NORTHEAST UTILITIES

Docket No. 50-423
 B11184

Millstone Nuclear Power Station, Unit No. 3
Summary/Submittal of Responses to RSB
Draft SER Open Items

Summary of the Status of RSB Items
from the NRC Meeting May 9, 1984

FIGURE 6.3-6
REFUELING WATER STORAGE
TANK WATER LEVELS
MILLSTONE NUCLEAR POWER STATION
UNIT 3
FINAL SAFETY ANALYSIS REPORT

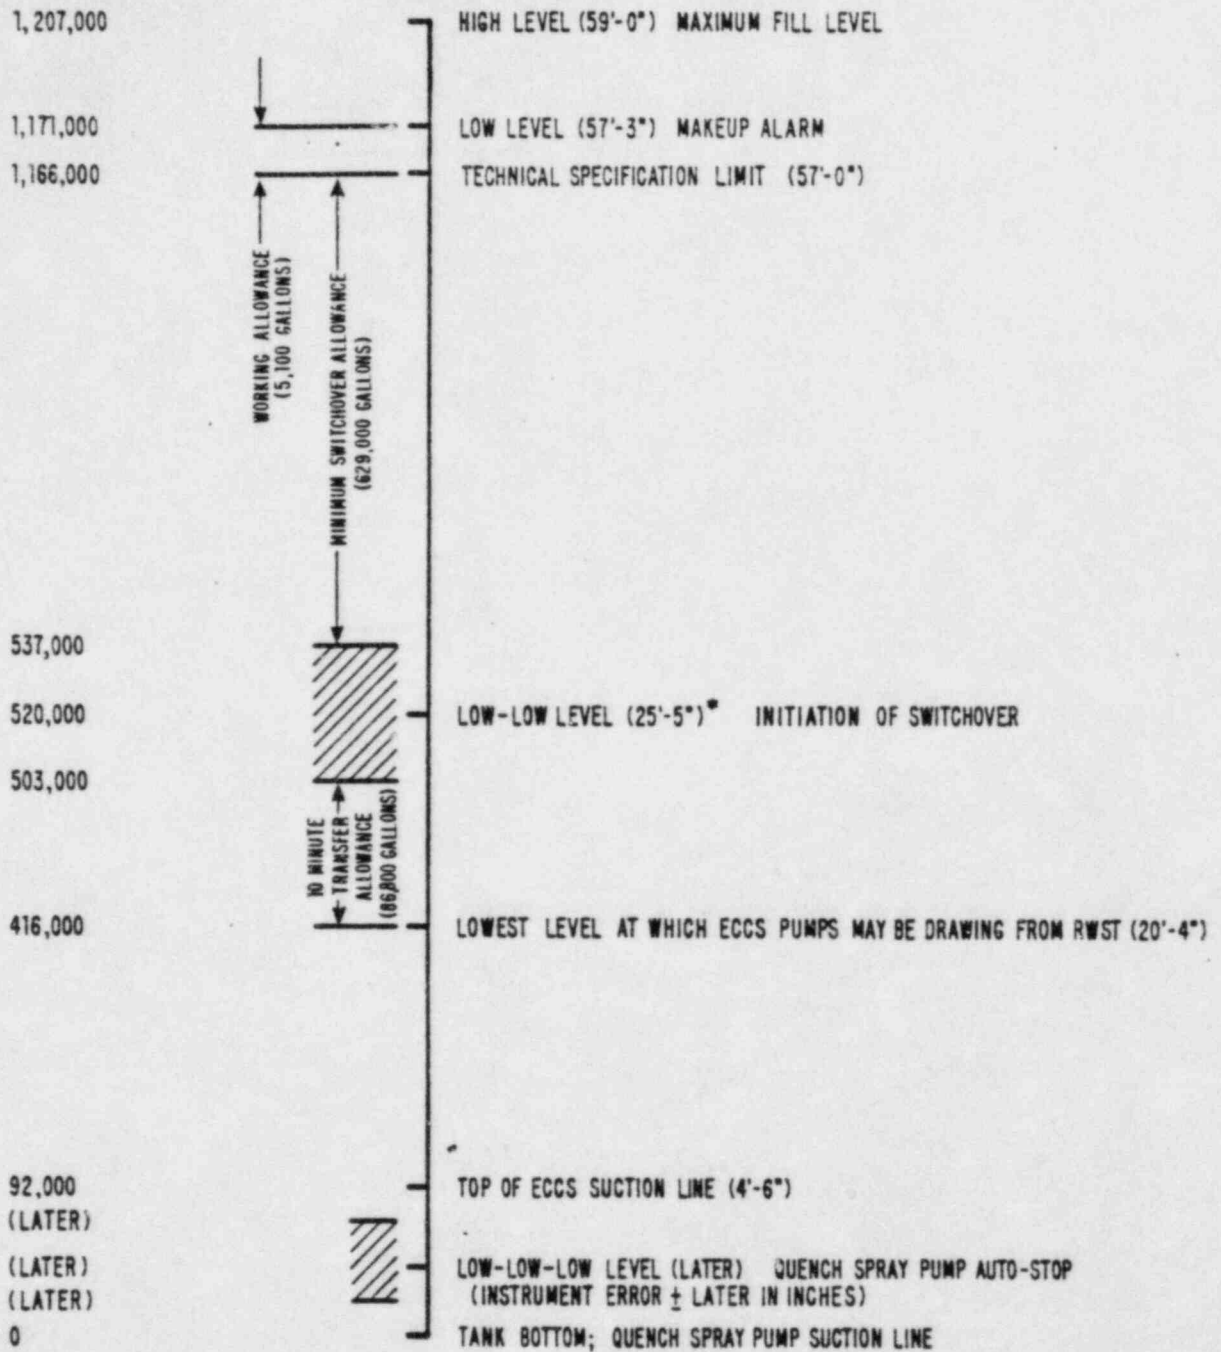
You state in Section 6.3.2.8 that the low-low RWST level signal is also alarmed to inform the operator to initiate the manual action required to realign the charging, safety injection, and containment recirculation pumps for the recirculation mode. What is the minimum time available for completion of switchover before the RWST water is exhausted? Provide your basis for this minimum time. Provide the detailed actions for switchover including actions to restore power to valves and an evaluation of the maximum time required for each operator action in switchover to recirculation. Identify the most restrictive single failure and its impact on the time required for switchover. What are the consequences of premature operator switchover to recirculation? Also discuss the consequences of the operator failing to act promptly within the minimum available time for switchover.

Recently, a similar plant has indicated that a design error existed in the sizing of their RWST. This error was discovered during a design review of the net positive suction head requirements for the containment spray and residual heat removal pumps. The review showed that there did not appear to be sufficient water in the RWST to complete the transfer of pump suction from the tank to the containment sump before the tank was drained and ECCS pump damage occurred.

In light of the above information, discuss the adequacy of your refueling water storage tank design. Provide a discussion of the necessary water volumes to accommodate each of the considerations indicated above. Justify your choice of volumes necessary to account for each consideration of tank suction lines, and level sensors.

As discussed in revised FSAR Section 6.3.2.8, single failure of one RHS pump to trip is the most limiting single failure that can occur during the switchover procedure as it causes the RWST level to drop faster than normal. However, this failure would be quickly corrected as the first action of the switchover procedure is verification of the pump trip. If one pump fails to stop, the flow would be stopped manually before proceeding on with the switchover procedure.

Because of the substantial volume of water remaining in the RWST at the initiation of switchover at the low-low level (FSAR Figure 6.3-6) and since there is significant margin in the NPSH available to the ECCS pumps (FSAR Section 6.3.2.2.3), there would be no adverse consequences to the ECCS if the operator failed to act promptly and complete switchover in the 10 minutes assumed for switchover. However, some water assumed available to the quench spray pumps for containment heat removal would be used by the ECCS. The loss of a portion of the QSS water is not a limiting condition since the assumed single failure to trip one RHS pumps allows full containment recirculation spray system operability to be assumed. Minimum ESF is the limiting failure in the containment depressurization design basis accidents discussed in FSAR Section 6.2.1.

Refer to revised FSAR Section 6.3.2.8 for a discussion of RWST water volumes for the necessary allowances.

Vortex formation at the inlet of the ECCS pumps suction line in the RWST will not occur, as the minimum RWST water level at termination of switchover is approximately 16 feet above the top of the ECCS suction line. Refer to revised FSAR Section 6.2.2.2 for a discussion of vortexing at the quench spray pump suction nozzles.

The minimum time that would elapse from initiation of a LOCA to initiation of switchover to the recirculation mode is then 629,000 gallons divided by 17,410 gpm, or approximately 36 minutes. This is the minimum time available for the operator to prepare for switchover. Refer to Figure 6.3-6 for a presentation of RWST water levels and volumes.

Should one of the residual heat removal pumps fail to stop automatically (limiting single failure), the RWST outflow would remain at a higher level until the operator took action to stop the flow from the RHS pump. This higher total outflow is conservatively assumed to be 12,560 gpm. The time to isolate RHS flow is

conservatively estimated to be 2 minutes. Assuming the higher outflow for 2 minutes, and then a constant outflow of 7,710 gpm for 8 minutes, approximately 86,800 gallons of water would be used during the assumed 10 minute switchover time.
